From: Rachael Oldroyd
Sent: 21 April 2021 10:03
To: Mark Hill
Subject: RE: NYM/2021/0220/FL - Boggle Hole Youth Hostel -

Planning reference NYM\2021\0220\FL

YHA (ENGLAND & WALES) LTD	client	
YHA BOGGLE HOLE REFUSE STORE	project	
PROPOSED PLAN & ELEVATIONS	title	ARCHITECTS
YHA46	job No.	
AP100 Rev A	dwg No.	3 Jordan Street Manchester M15 4PY 0161 237 5500 info@justharchitects.co.uk
1:50 @ A1	scale	
DRAWN	drawn

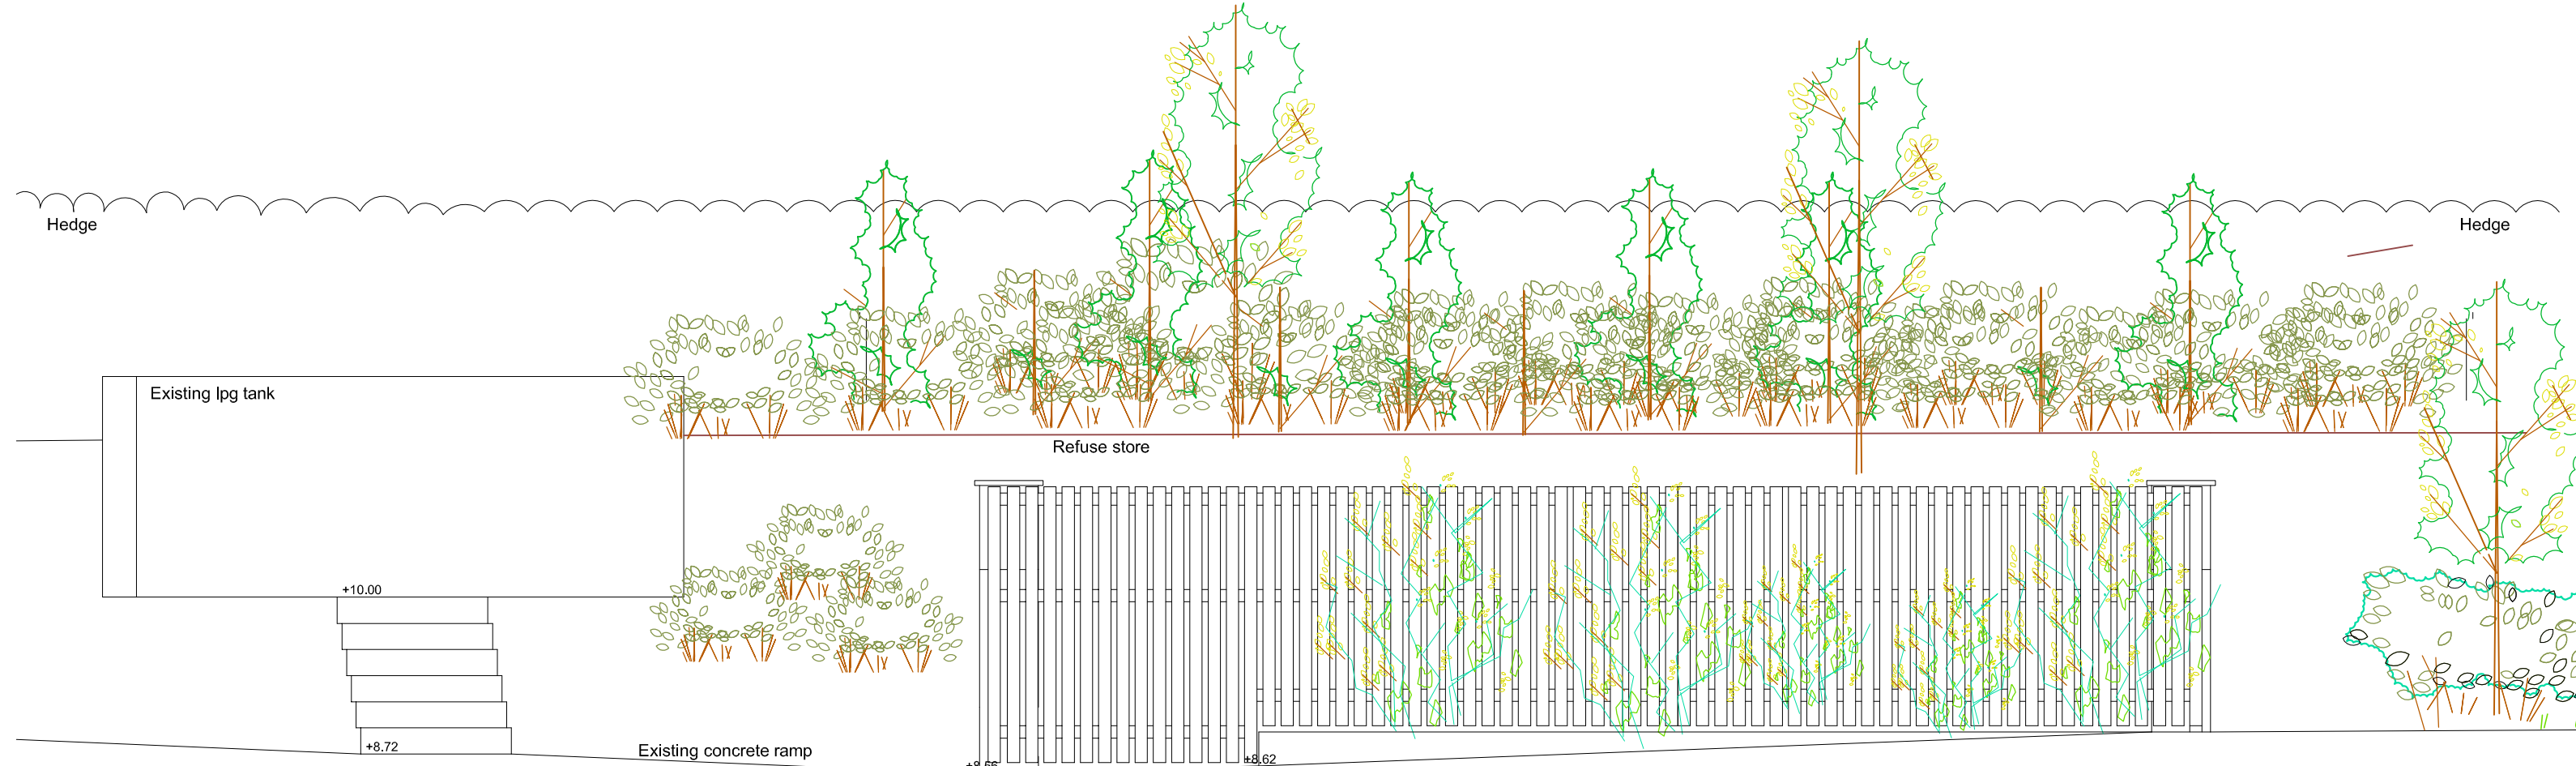
The A-A cross section shows a maximum height of 1.9m, which I believe, means the back retaining wall will be removed down to a height of 1.85m.

Please can you confirm this is correct? **Yes, the back wall will be lowered to meet the height of the front wall.**

West Elevation

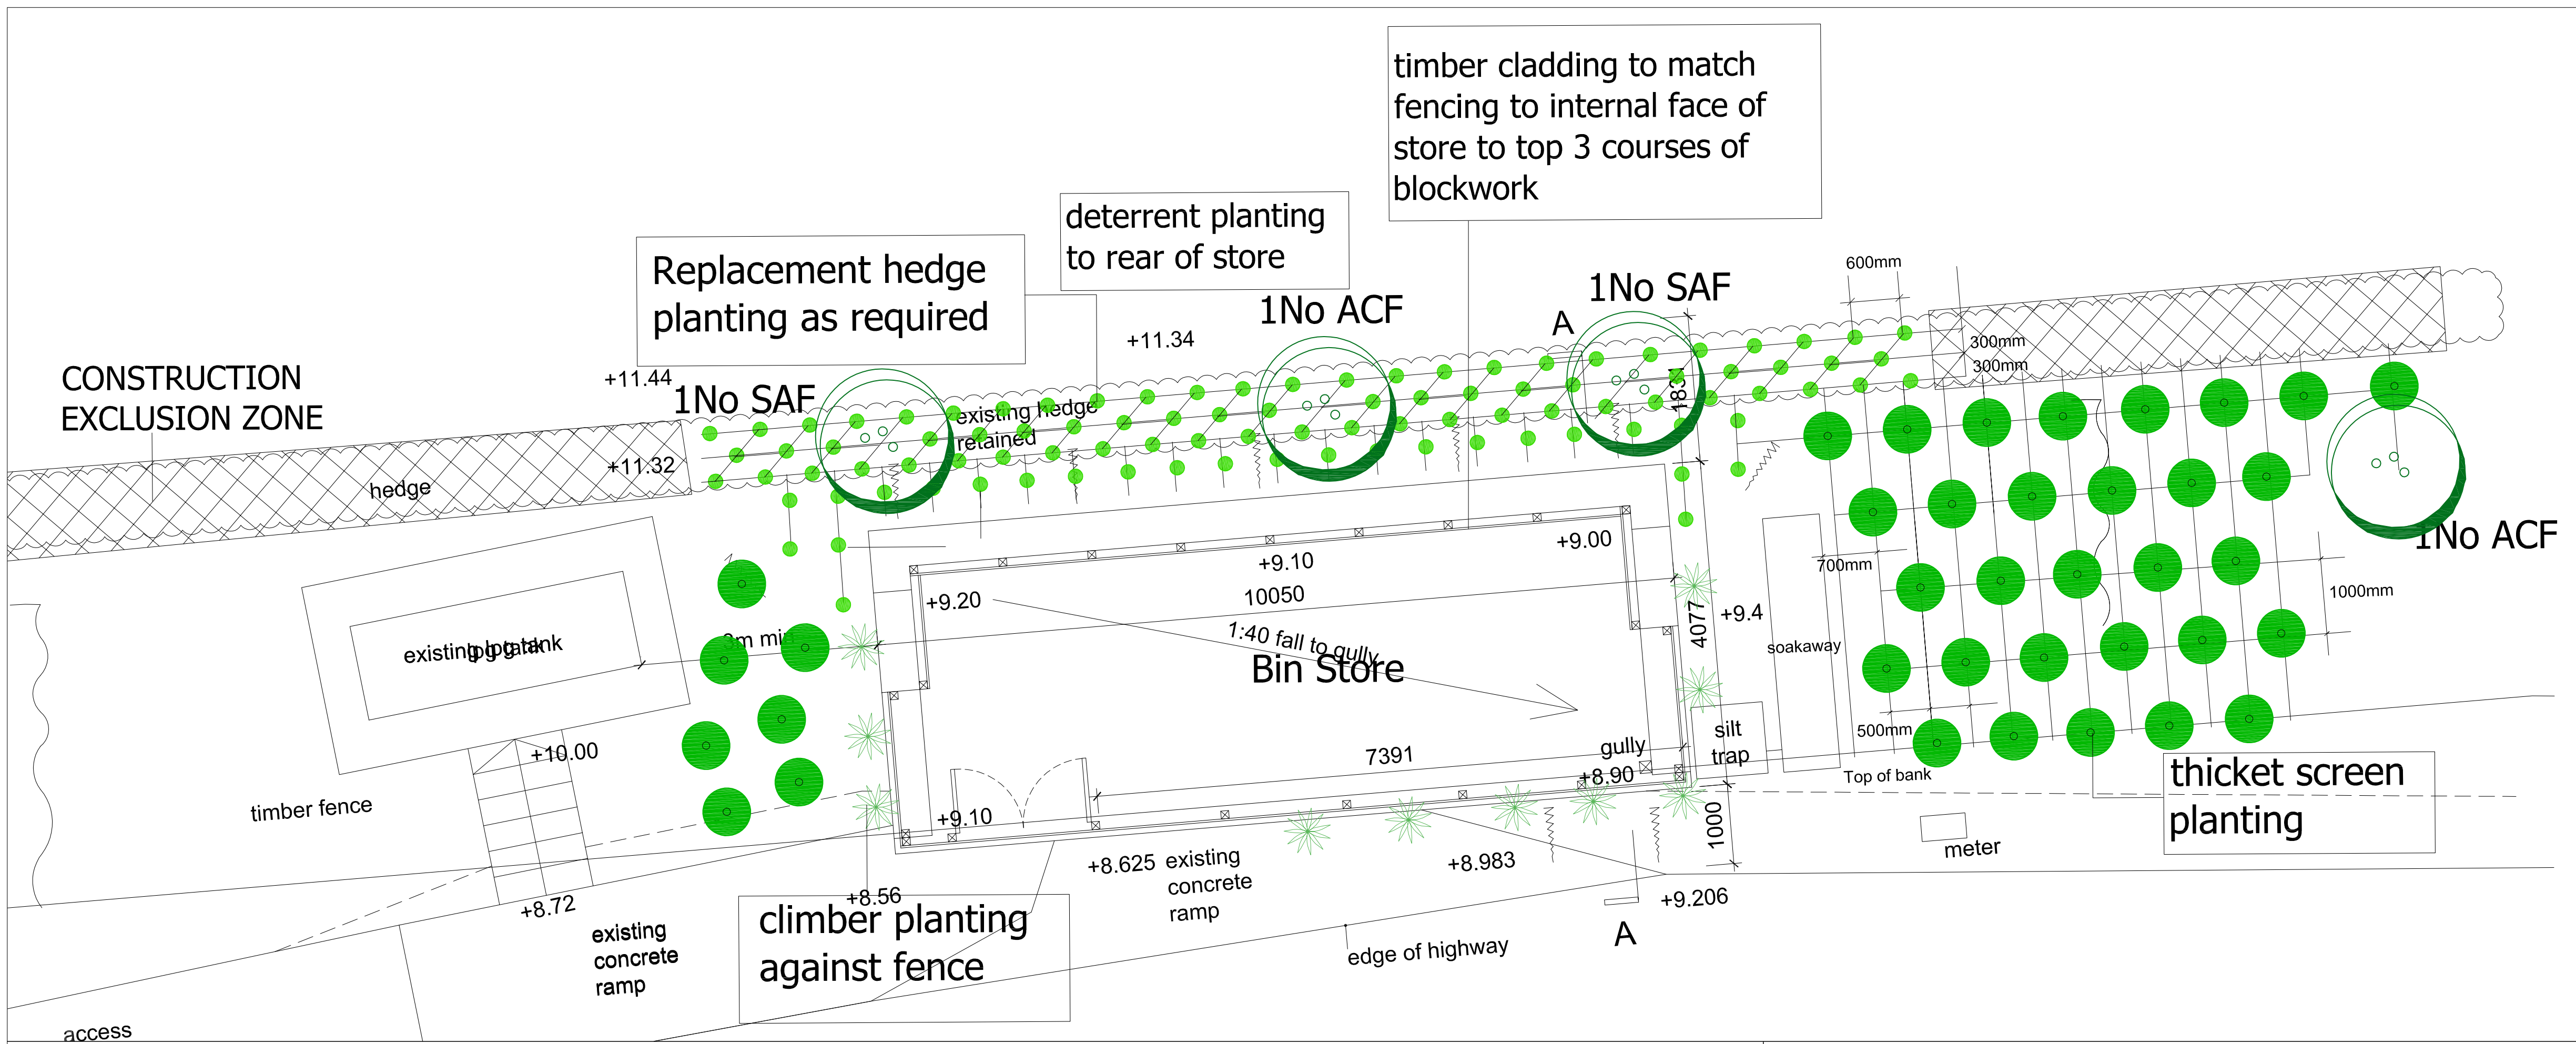
The front elevation shows the fencing as almost parallel in height, showing the South side, right-hand end as 1.90m and the North side on the left-hand end as 1.8m.

Does this mean the existing 2.4m height at the North end is to be reduced down from the top to achieve the proposed height of 1.8m, or am I correct in assuming the existing top height point of the palings will not change, but the ground will be raised towards the North end to reduce the length of the palings? **This is a drafting error that has now been corrected on the west elevation, the ground level was shown correctly but the base of the fence was not amended, the corrected drawing is now attached.**

The Plan view shows the Gates in the existing position with the climbing plants in front of them! yet the front elevation shows the gates in a proposed more central position. Would you explain which drawing is correct please?

REVISION		180321	RCO
-	FIRST ISSUE	210421	RCO
A	Base of fence corrected on west elevation
